RESIDENTIAL FLAT BUILDING DEVELOPMENT

17 (LOT 1 DP 973520), 19 (LOT 1 DP 972422), 21 (LOT 1 DP 972554) SHIRLEY ROAD, ROSEVILLE NSW 2069

DEVELOPMENT APPLICATION

Schedule of Changes (RFI)		
ITEM NO.	DESCRIPTION	DRAWING REFERENCE
PLANNING AND URBAN DESIGN		
ITEM 1.1	Ground Floor and Level 1 courtyards revised to balconies at building setback, and replaced with deep soil landscaping.	AR 103, AR 104

DRAWING TITLE
Demolition Plan

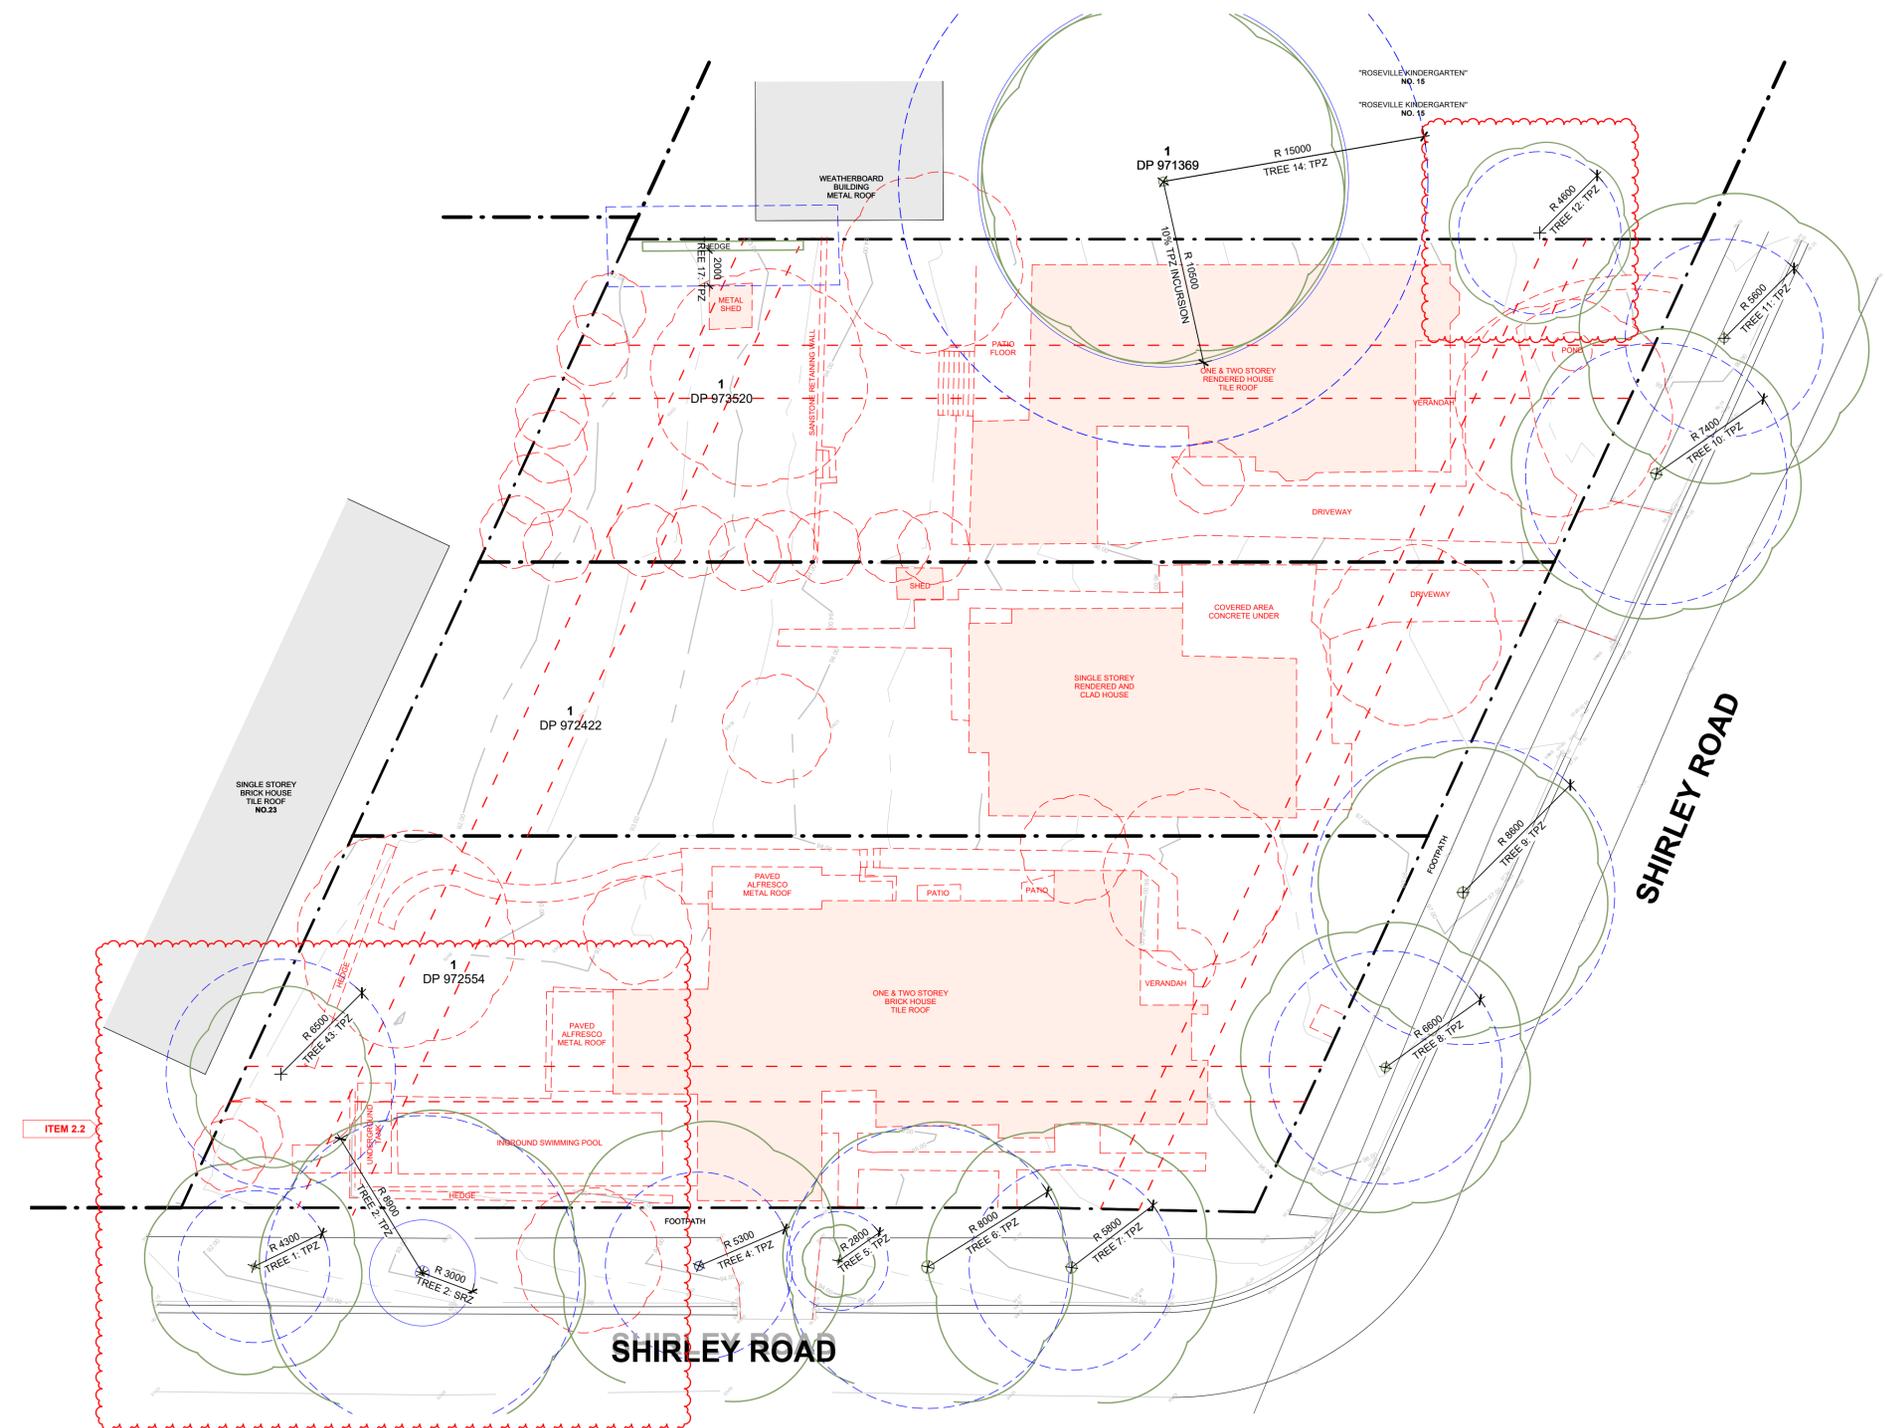
ITEM 2.1	Ground Floor & Level 1 courtyards deleted to significantly increase the amount of Deep Soil areas, with 6m minimum dimension.	AR 010
ITEM 2.2	Design amended to accommodate the retention of trees 2, 12, 43 and 6, including changes to driveway location and removal of courtyards and associated retaining walls.	AR 003, AR 103

DRAWING TITLE
Basement 1 GA Plan

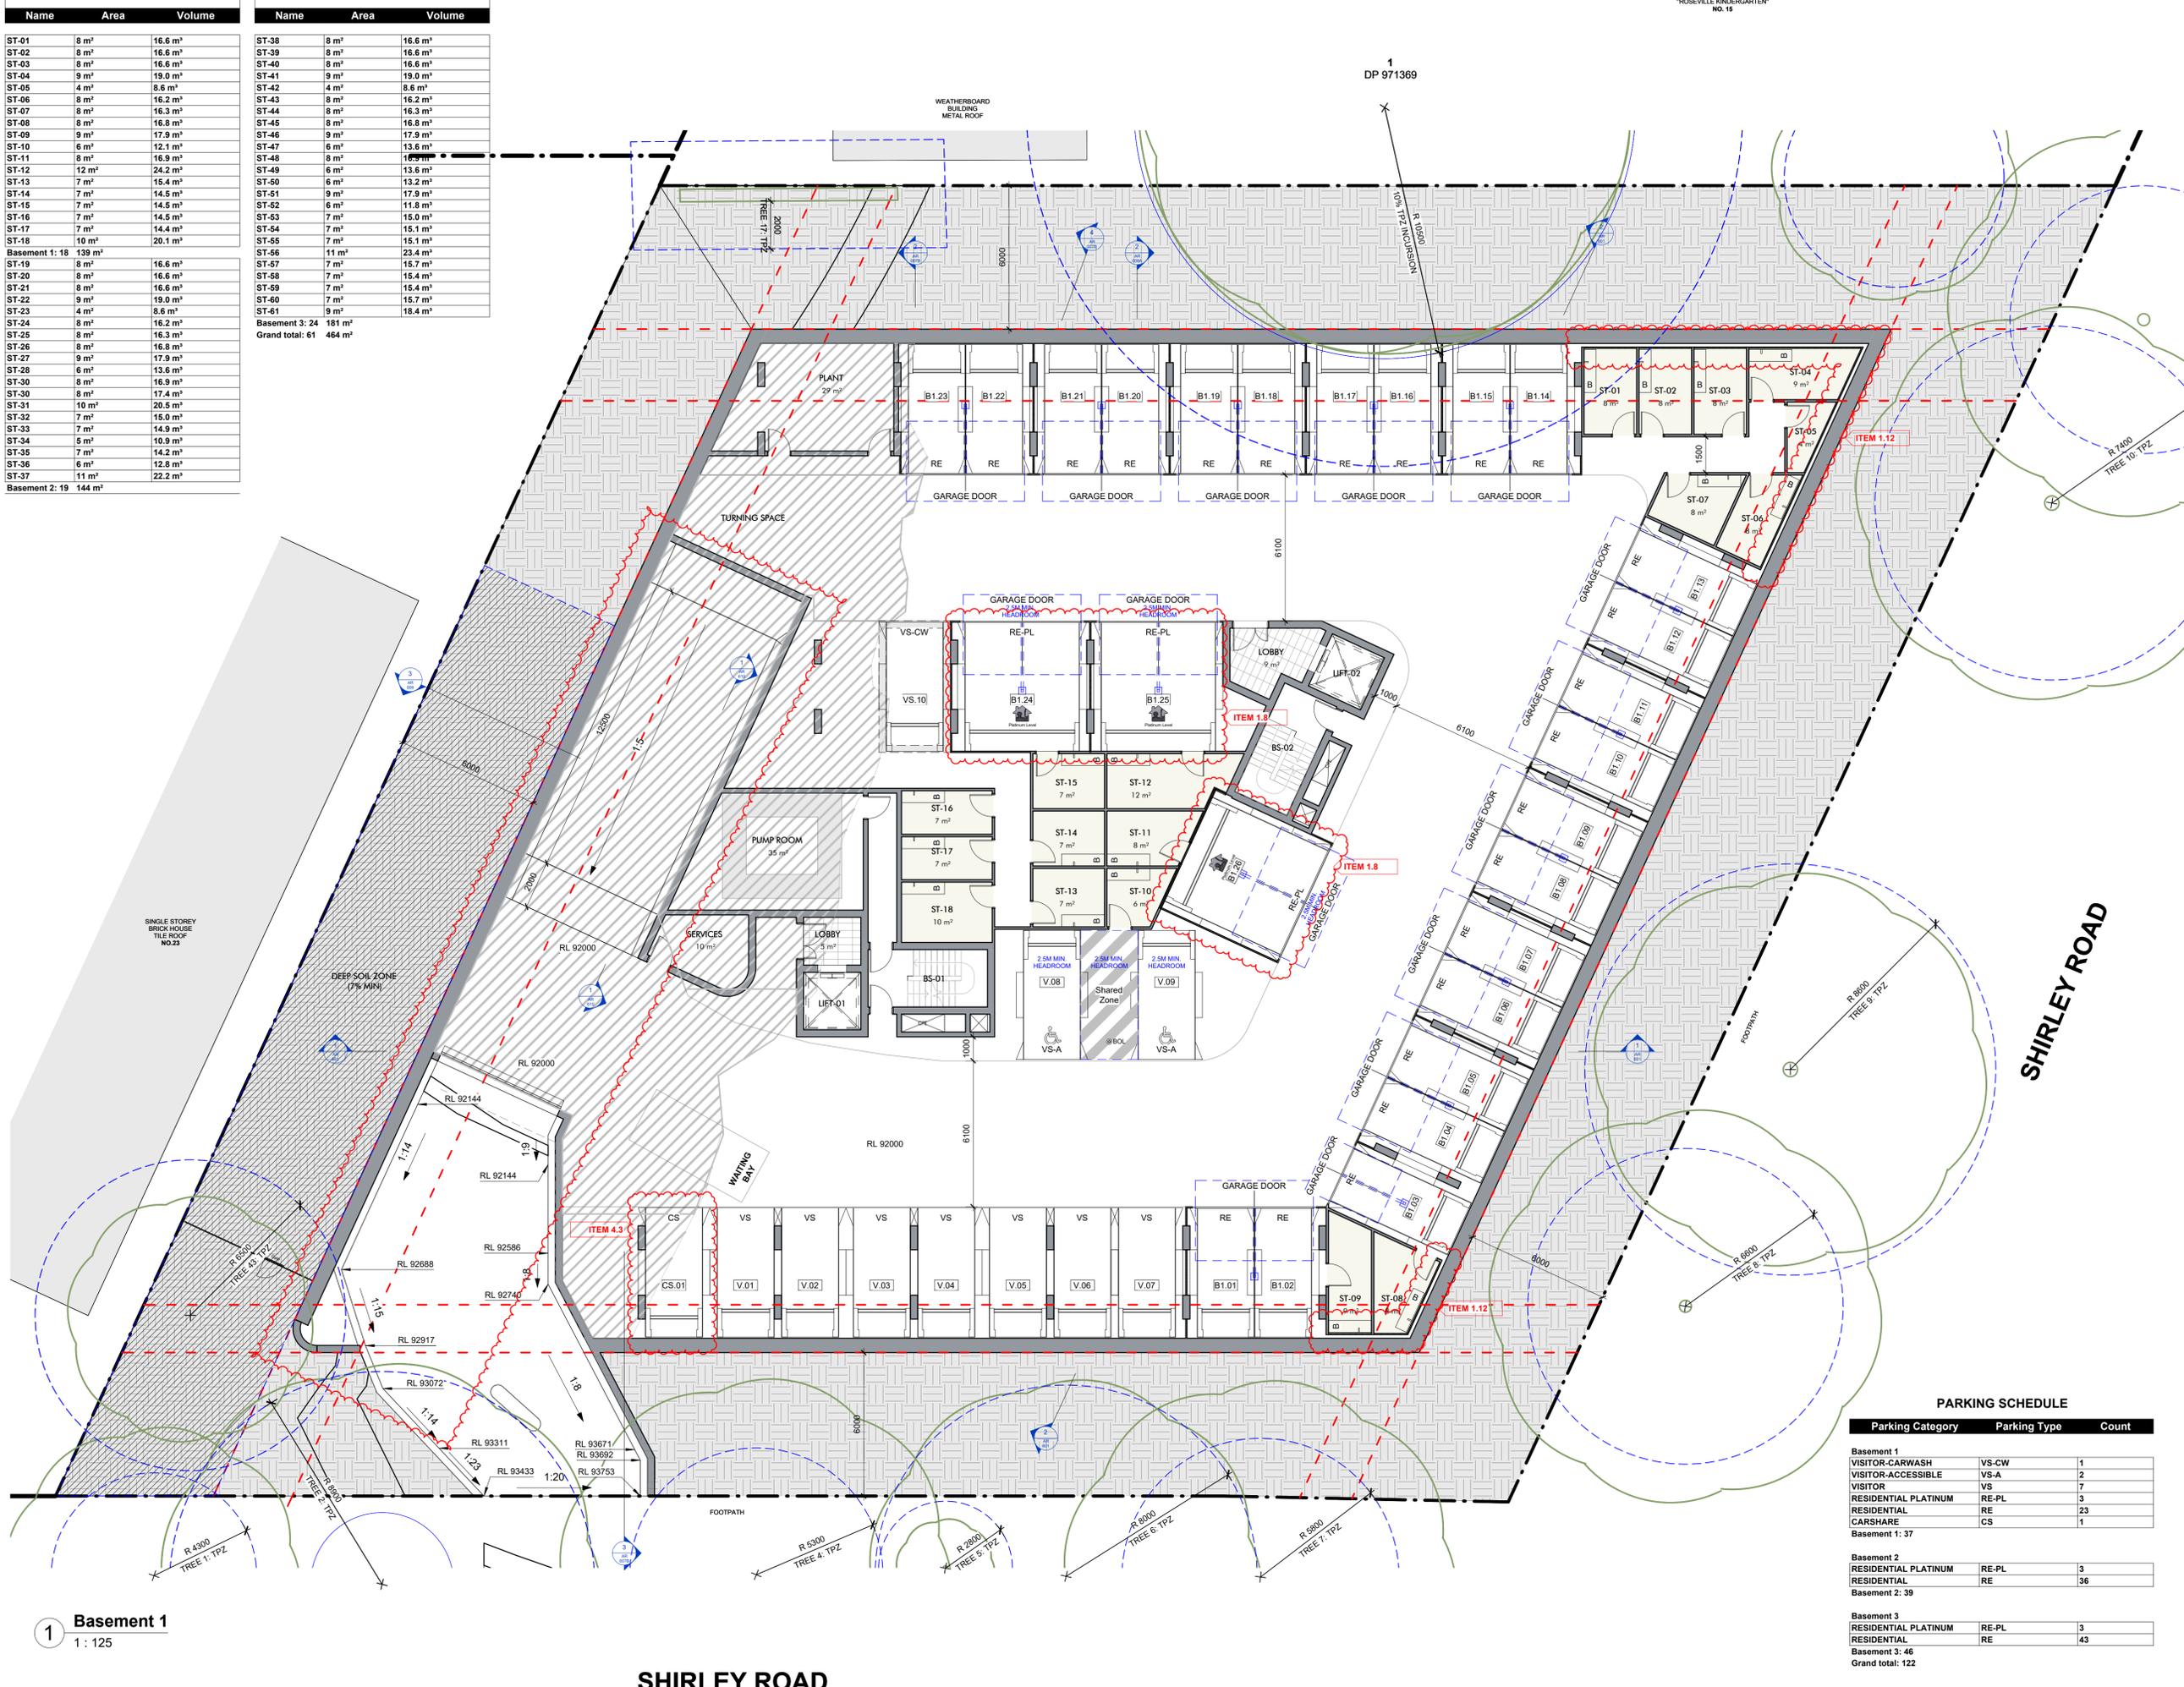
ITEM 1.7	Affordable Units revised. Total area provided demonstrating at least 2% of GFA will be used for affordable housing.	AR 001, AR 007
ITEM 1.8	Total of nine (9) Platinum Level Livable units and car spaces provided to achieve 15% of total apartments.	AR 001, AR 100, AR 101, AR 102, AR 104, AR 106

ITEM 1.12	Storage walls adjacent to external shoring walls amended to mesh for maintenance.	AR 001, AR 100, AR 101, AR 102, AR 104, AR 106
ITEM 1.13	GFA Plans increased in scale, additional sheet added.	AR 007, AR 007A
LANDSCAPING

ITEM 4.1	OSD revised per Council comments. Refer Stormwater engineer's documentation.	AR 103, Stormwater Drawings
ITEM 4.2	Parking layout revised. Excess car spaces shown as GFA, subject to clause 4.6 prepared by the Town Planner.	AR 007, AR 100, AR 101, AR 102

ITEM 4.3	One (1) car share space provided at Basement Level 1.	AR 102
ITEM 4.4	Visitor bicycle parking spaces relocated to entry area at Ground Floor.	AR 103

DRAWING TITLE
Ground Floor GA Plan

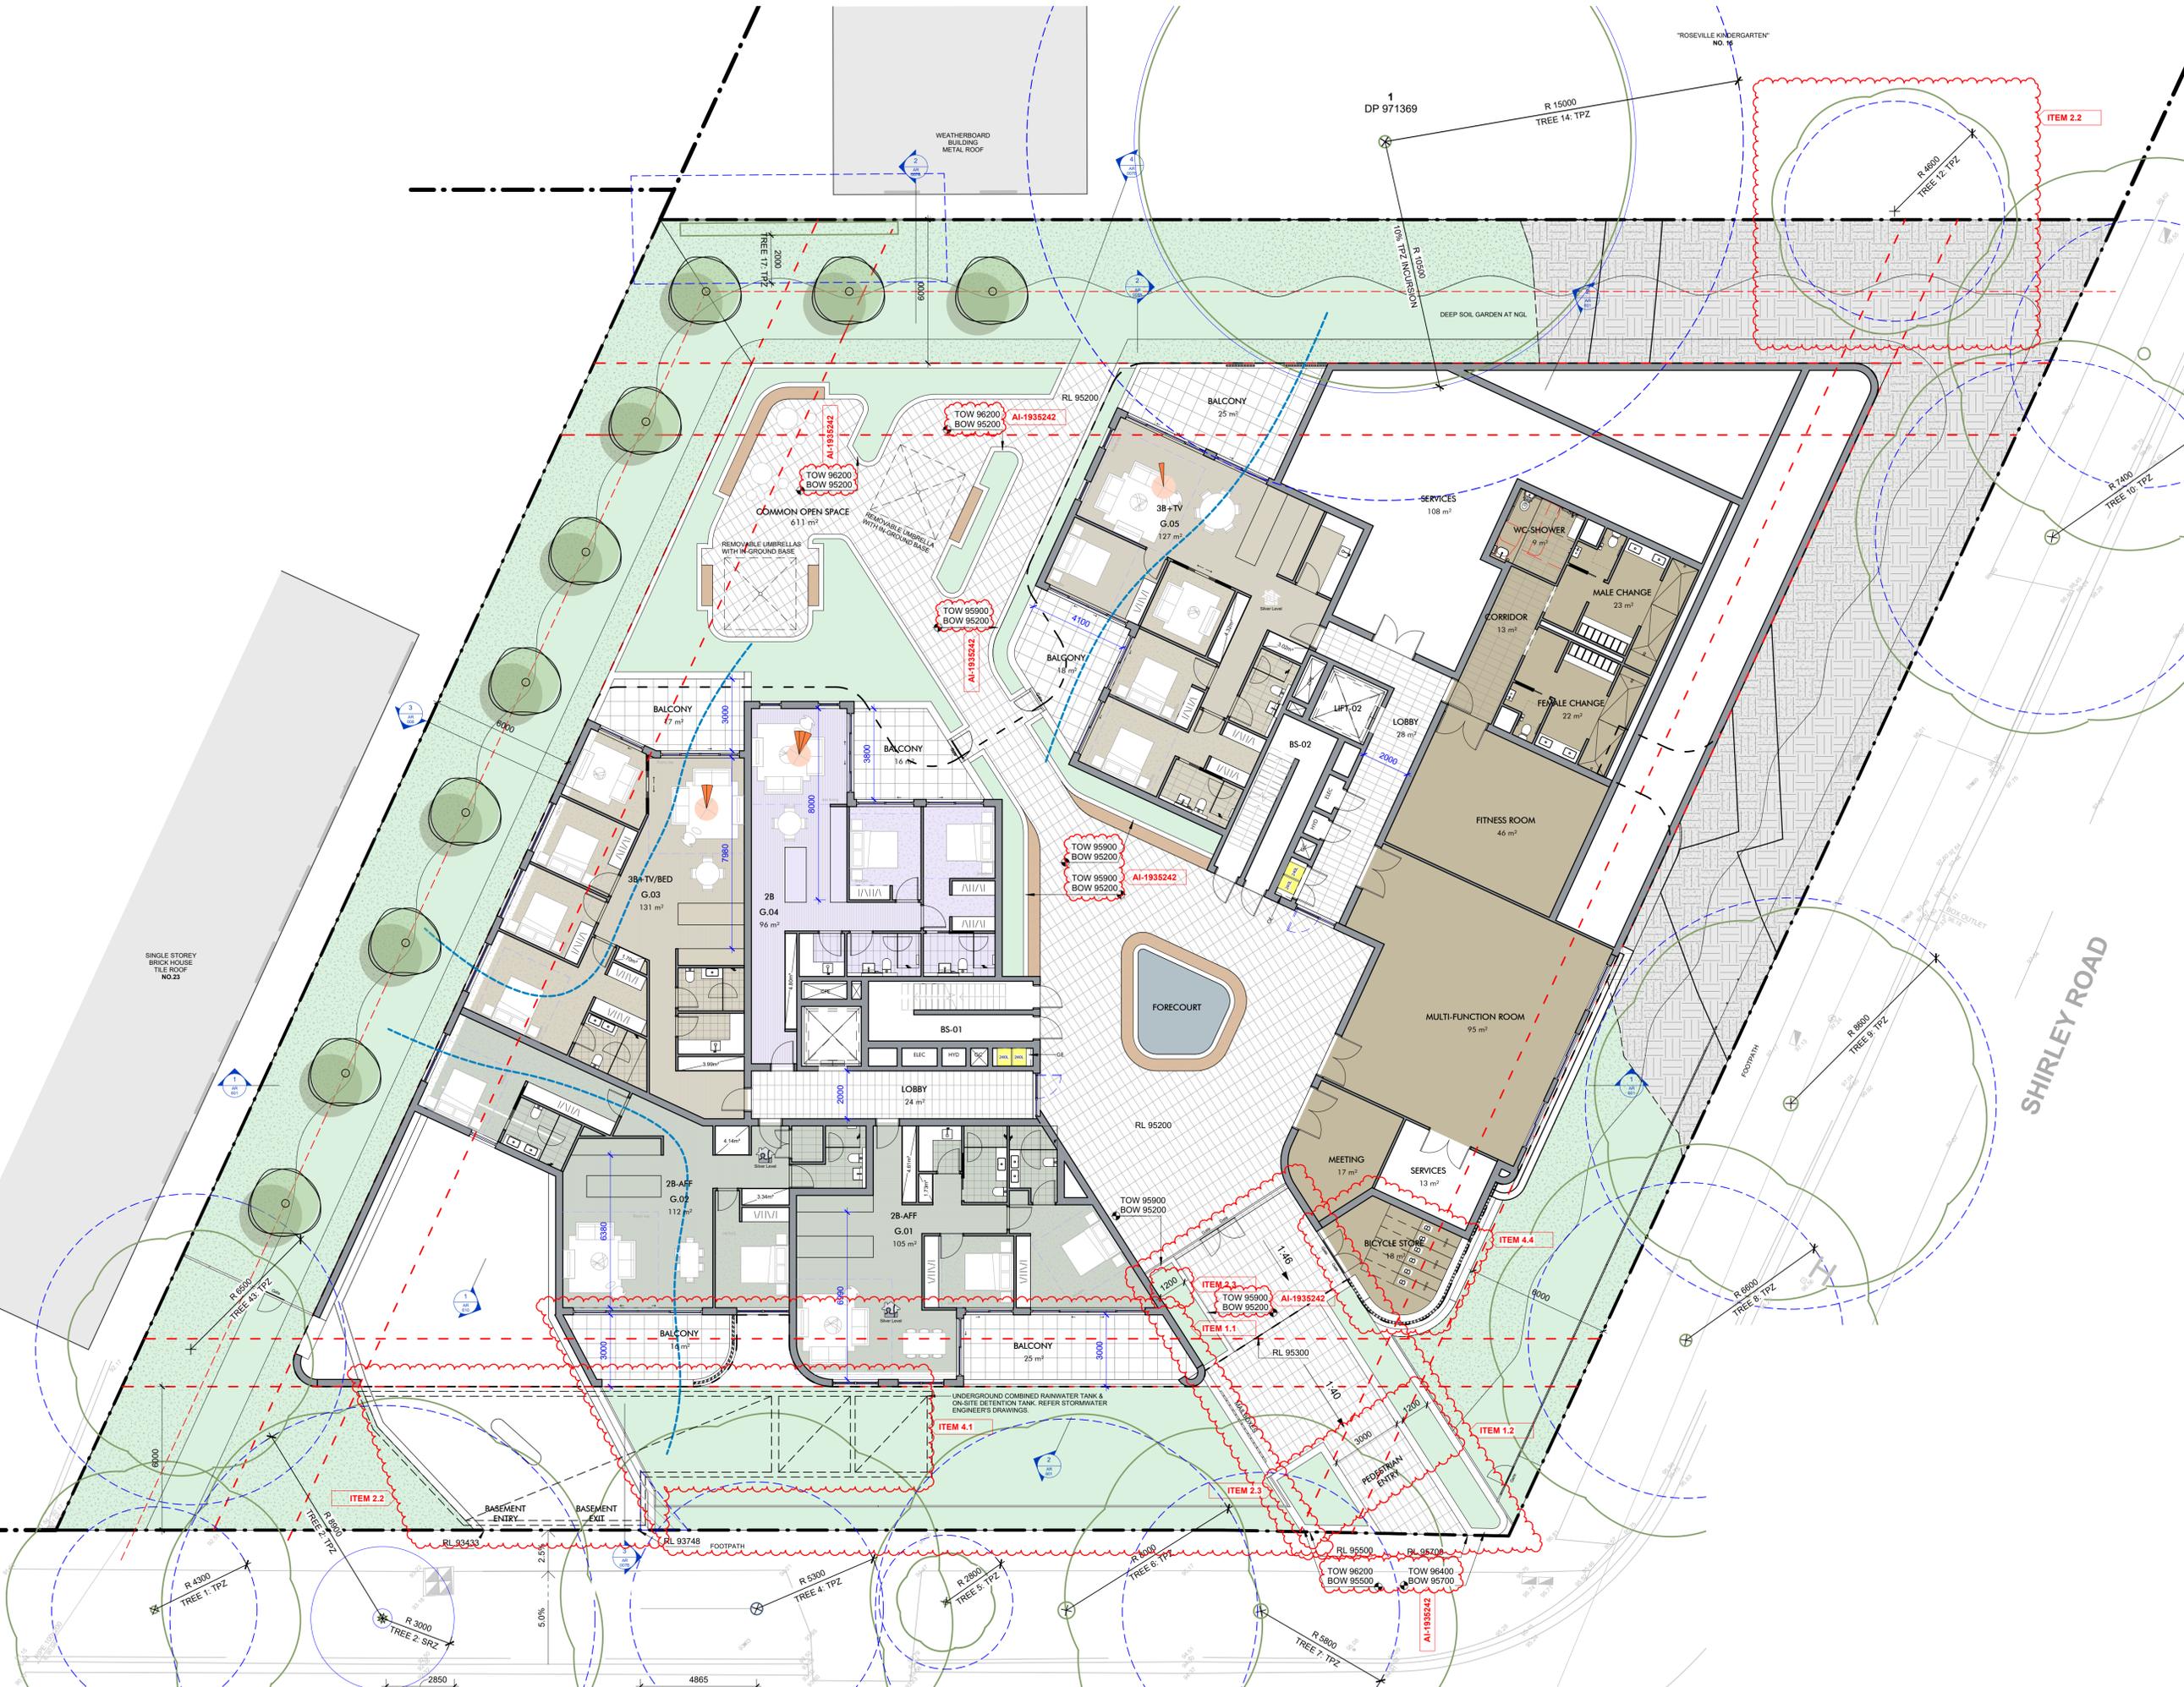
ITEM 1.2	Building levels amended to allow accessible street entry without stairs or platform lifts i.e. 1 in 40 maximum grade.	AR 103
ITEM 1.3	Levels above four storeys amended to maintain 9m setback from the site boundaries.	AR 105, AR 106, AR 107

ITEM 2.3	1.2m minimum wide planters shown at entry path. Courtyards and associated retaining walls deleted to address comments regarding earthworks. Refer to landscape consultant's documentation for drawings addressing planter depth and tree replantment.	AR 103, Landscape Drawings
HERITAGE
